HAM2-H1

Luke's Layout

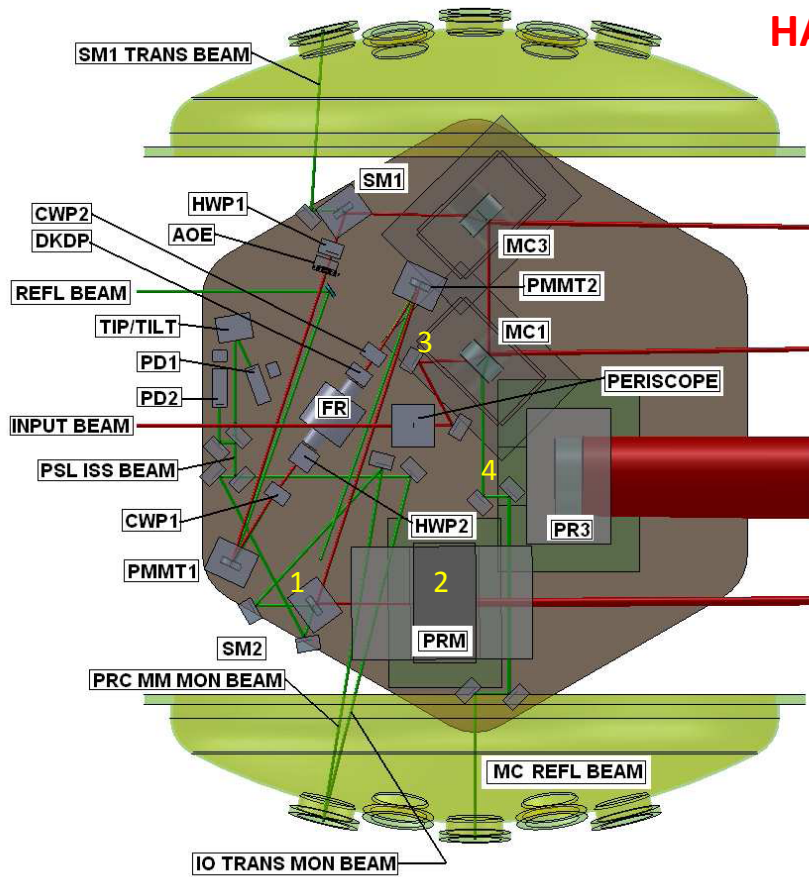
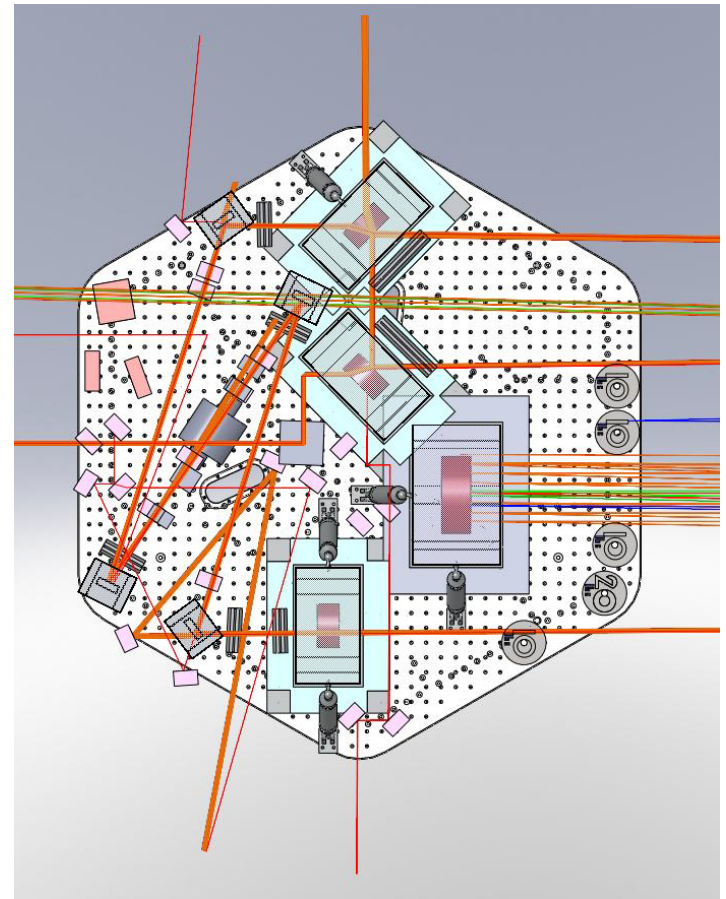
Most of the Laser Beams are pretty much on target (on X & Y Axis) except for the following components:

- 1- SM2: $X = -559.5$; $Y = 630.9$; $Z = 100$; $Yaw = 143.531^\circ$
- 2- PRM: $X = -69.9$; $Y = -628.0$; $Z = -96.8$; $Yaw = 179.574^\circ$
3. Missing Component ID and Coord's. Laser Beam path is Different from Actual layout
4. Laser Beam path is lower than in actual layout.

HAM8-H2

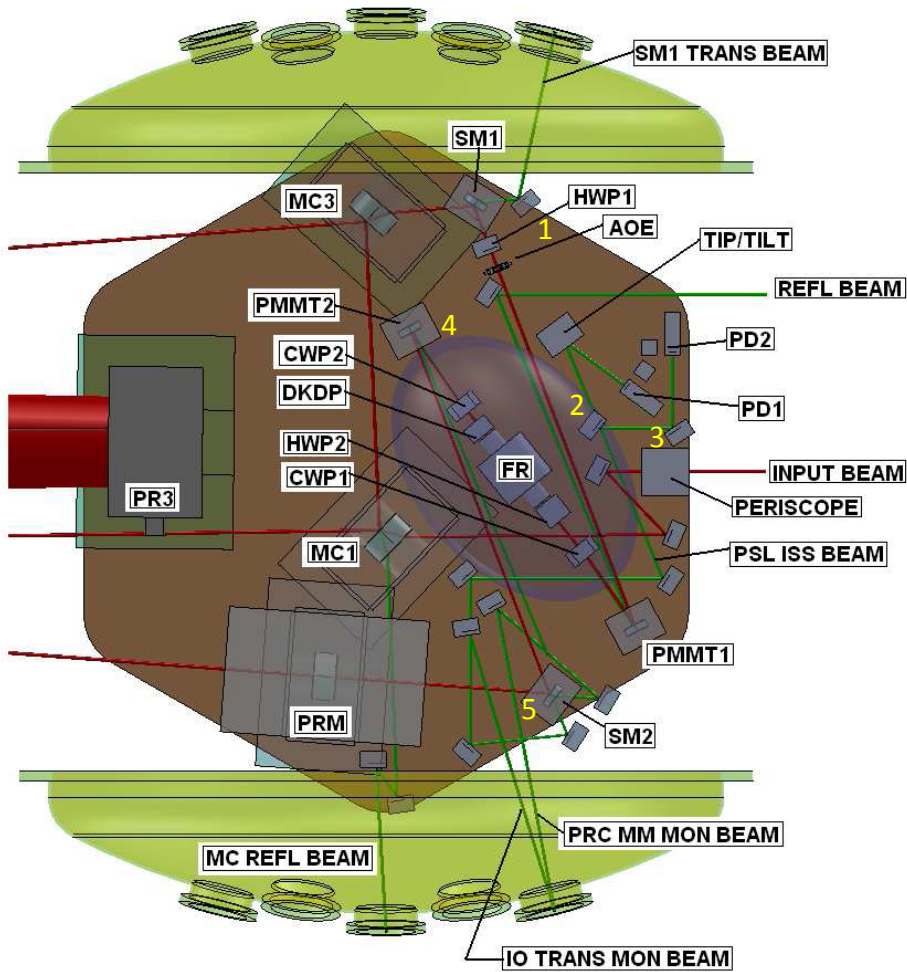
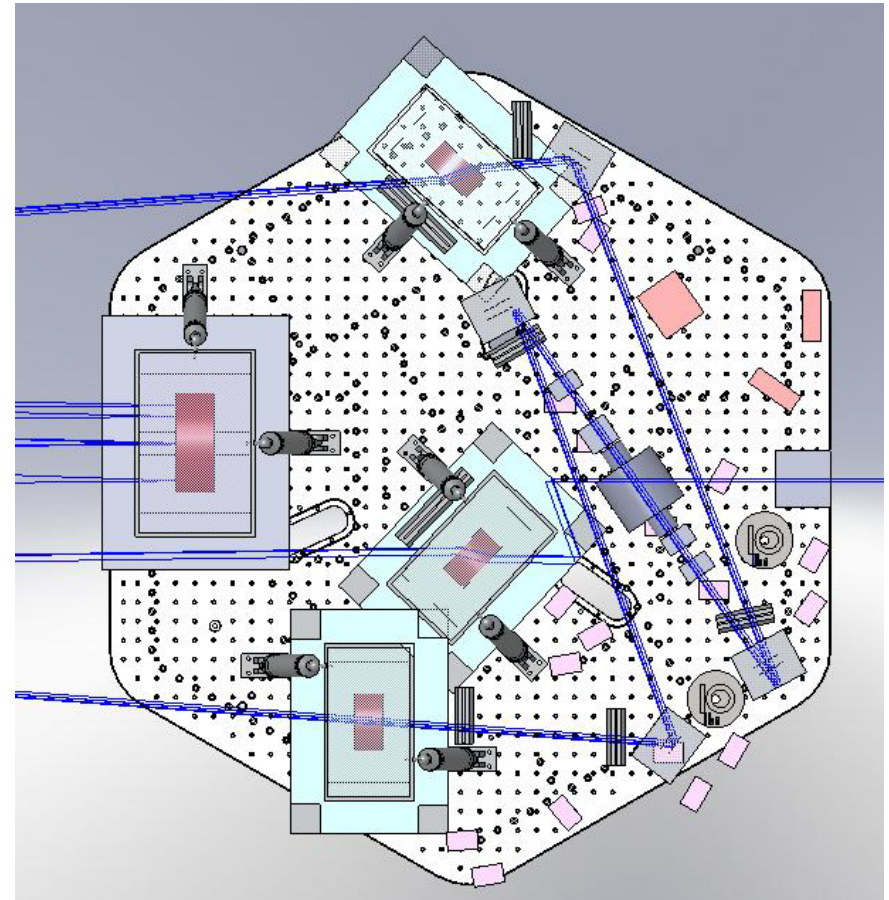
1, 2 & 3 are missing components in actual layout.
I need ID and coords.

4 & 5 look out of position on actual layout. Maybe with latest
Zemax file, they are OK
